COMMITTEE OF THE WHOLE JUNE 5, 2012

SITE DEVELOPMENT FILE DA.12.021 ROYBRIDGE HOLDINGS LTD. WARD 2 - VICINITY OF REGIONAL ROADS 7 & 27

Site Plan

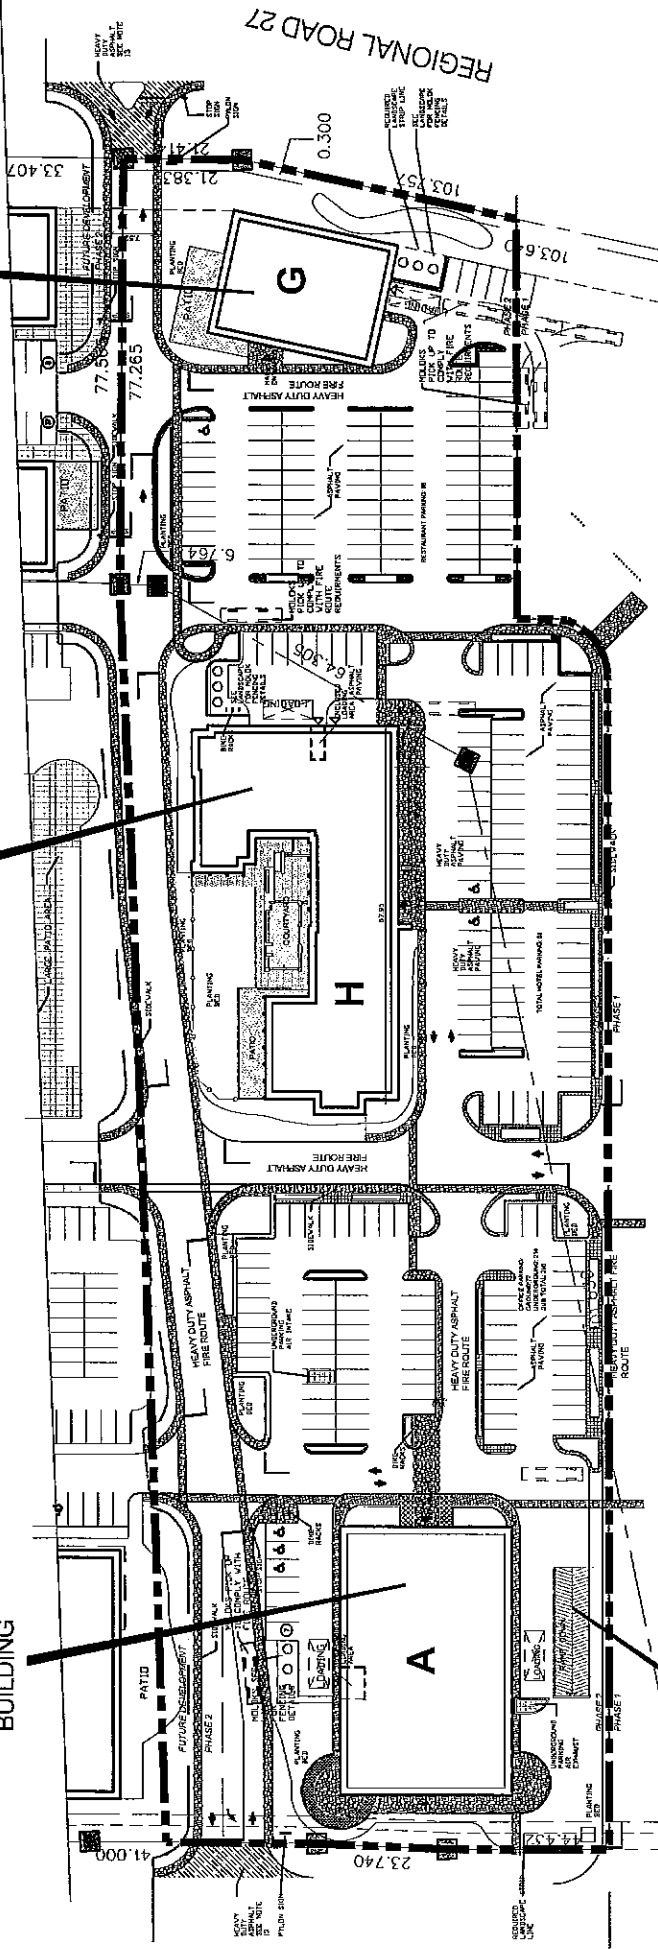
The southerly portion of the site (Vaughan Valley Centre - Phase I) is currently developed with a hotel, financial institution, restaurants, and a multi-unit service commercial building (Attachment #6). The proposed development shown on Attachment #3, which constitutes Phase II, includes a seven-storey 10,394.6 m² hotel (Building "H" - Westin Element), a six-storey 8918.7 m² office building (Building "A"), and a 696.8 m² building footprint for a future restaurant (Building "G"). Access to the site is provided from Vaughan Valley Drive to the west, Regional Road 7 to the south, and Regional Road 27 to the east (the latter access is subject to York Region approval). A vehicular and pedestrian connection is proposed to run east/west through the site, at the northern limit of the Phase II development.

The Development Planning Department is generally satisfied with the proposed site plan, landscape plan, and building elevations, and will continue to work with the applicant to finalize the drawings. A provision to this effect is included in the recommendation of this report.

Landscape Plan

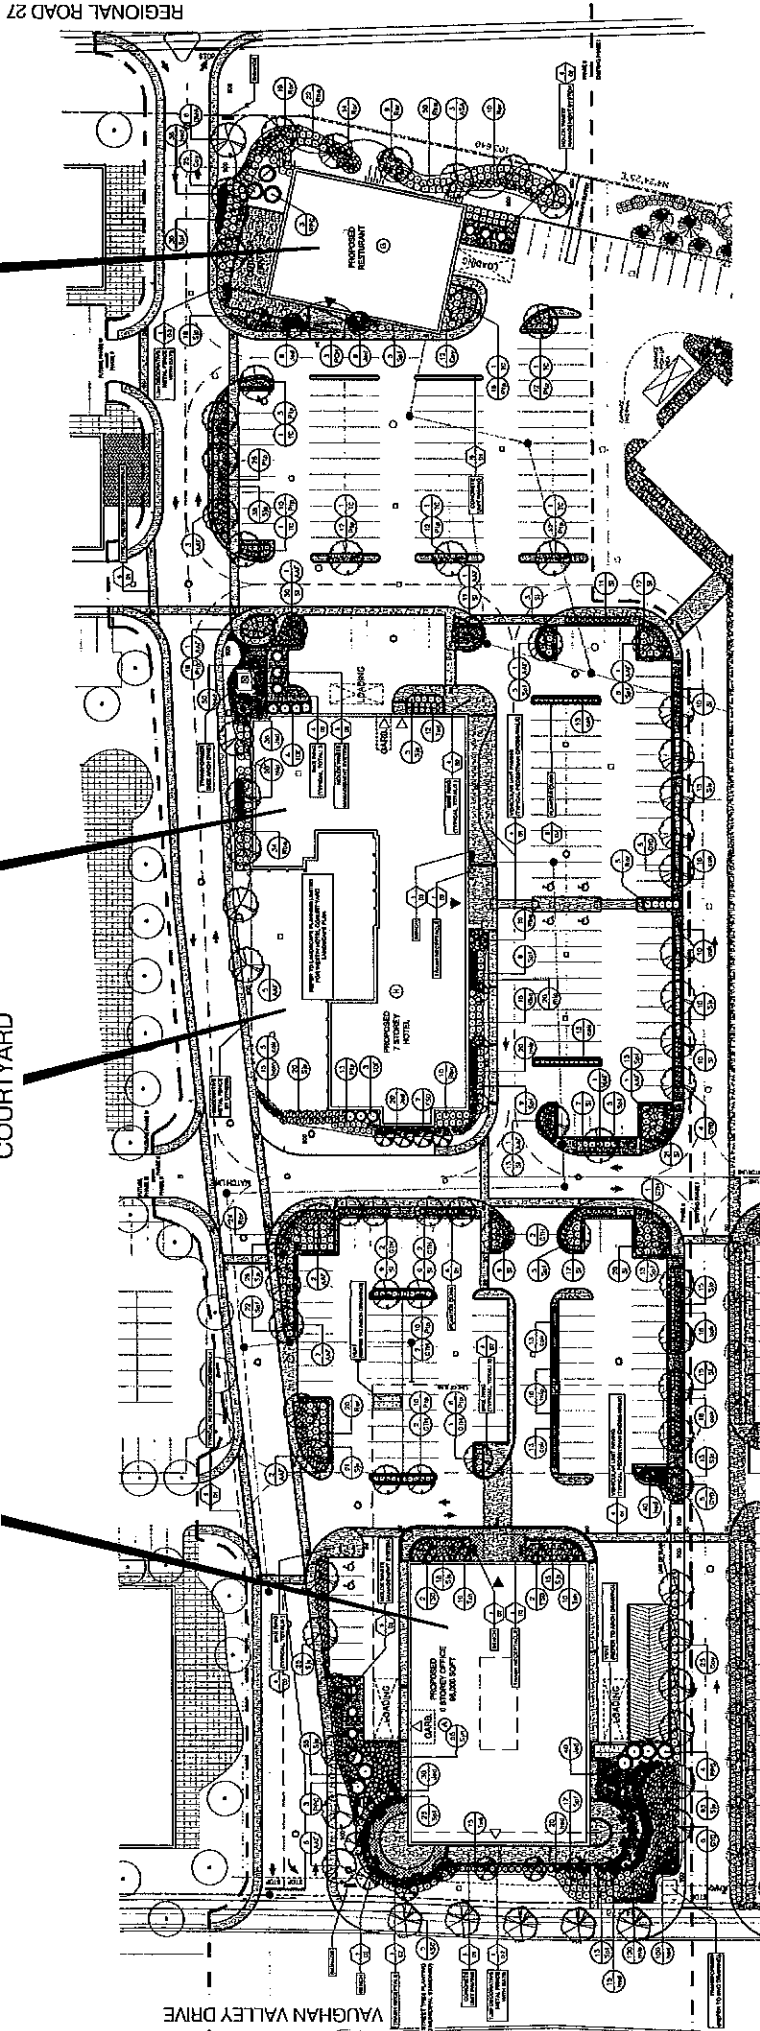
The landscape plan shown on Attachment #4 consists of coniferous and deciduous trees, shrubs, flowers, and grasses. The detailed landscape plan for the hotel courtyard shown on Attachment #5 proposes unit paving, planting beds, and private seating areas for the hotel guests. Pedestrian linkages are proposed between the buildings, and bicycle racks are provided on select areas of the site.

Conceptual Master Plan

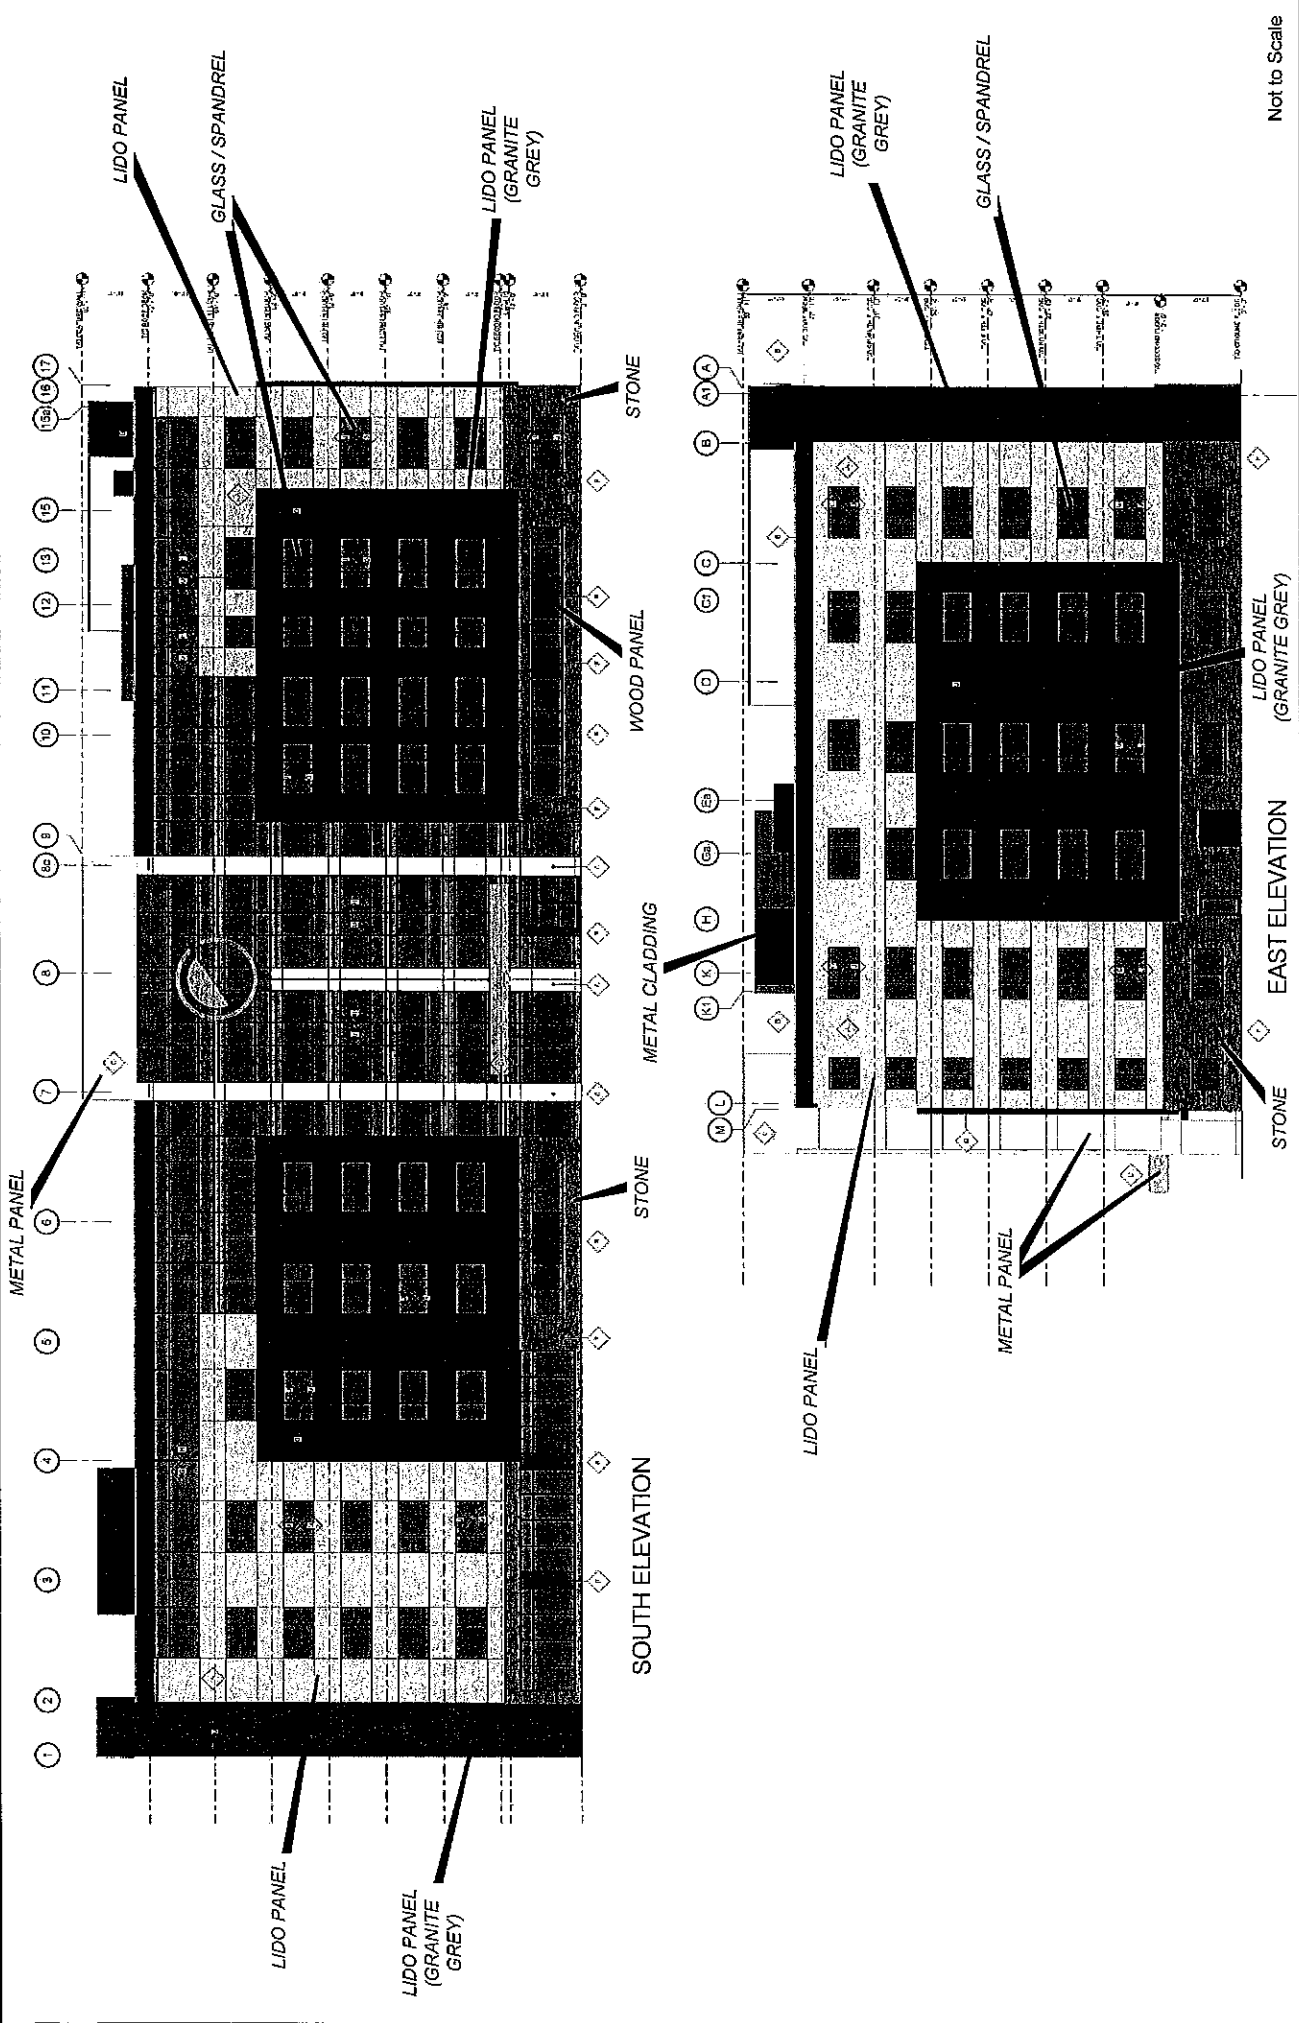
The conceptual master plan and ultimate build-out of the site shown on Attachment #6 includes a banquet hall, office building, four service commercial buildings, and a multi-unit industrial building. Development of Phase III will require submission of a separate Site Development Application for approval by Council.

For future development, the Development Planning Department encourages the Owner to intensify the site and provide transit-supportive densities in accordance with the Official Plan

provisions. The site plan, building orientation, and building massing should be designed primarily for pedestrians and public transit users, while sustainable development initiatives should inform the entire site design.

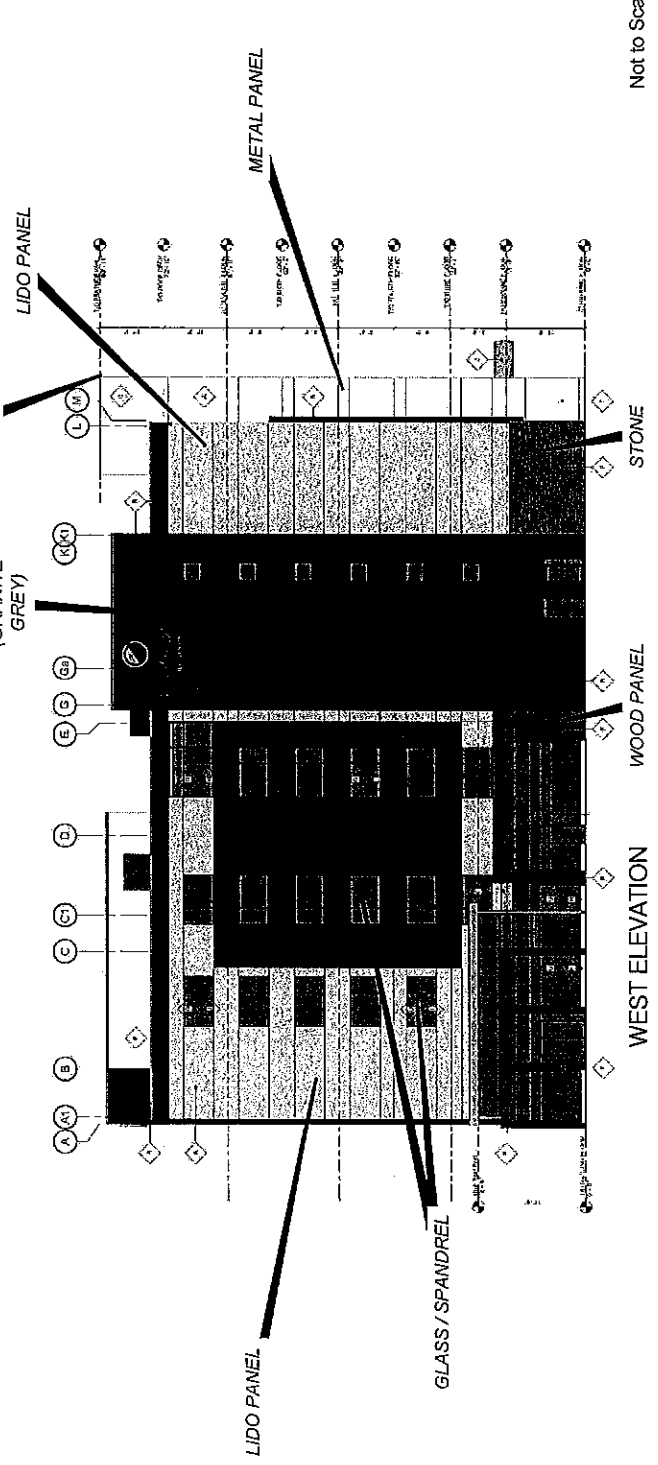
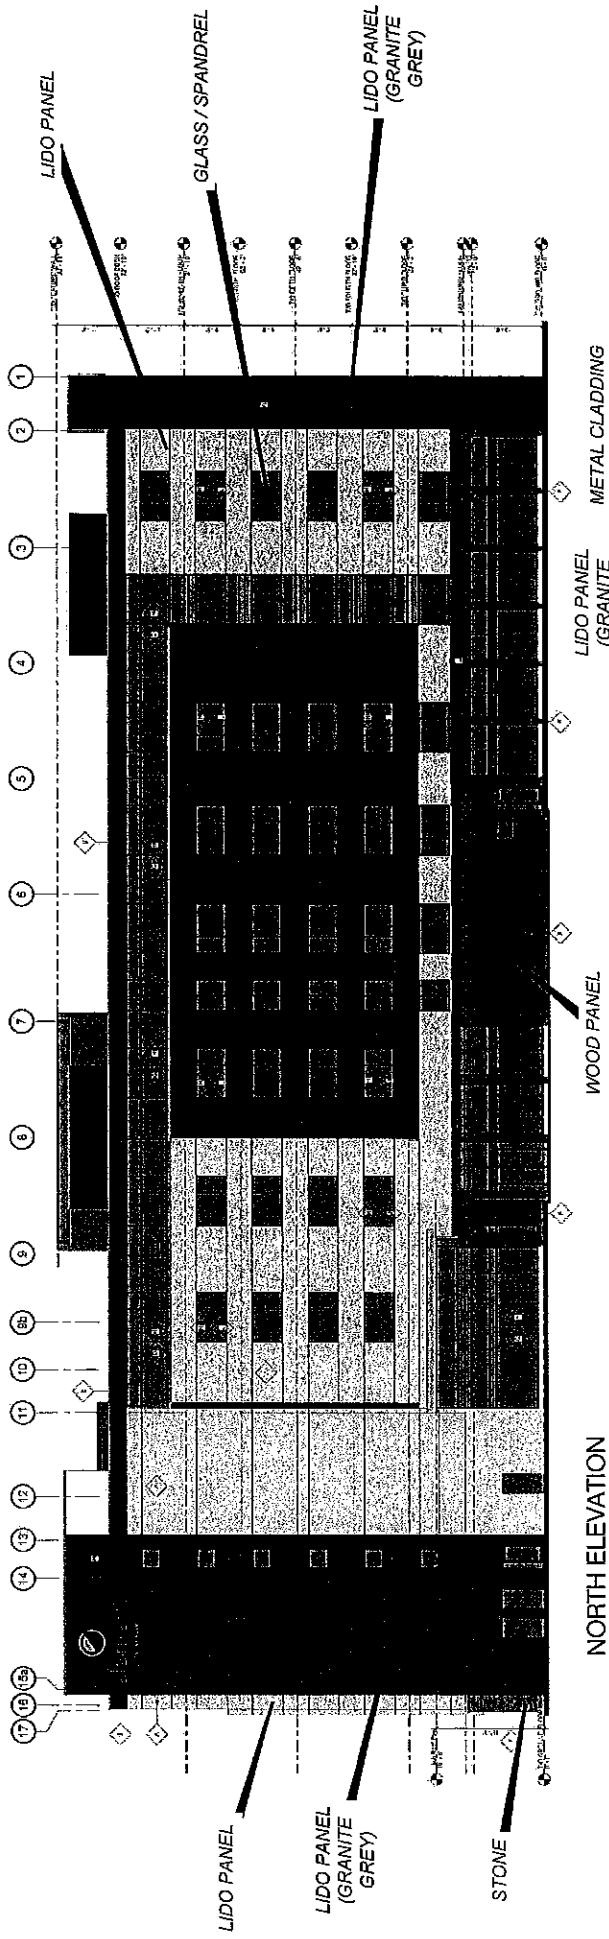
The building elevations for the hotel and office building are shown on Attachments #7 to #10. The hotel consists of grey and beige lido panels (EIFS), and glass/spandrel windows with stone and wood aluminum paneling at the base of the building. As EIFS is easily punctured and tends to retain moisture, the Development Planning Department will require on the final elevation plan that the base of the building be comprised largely of precast concrete or stone.
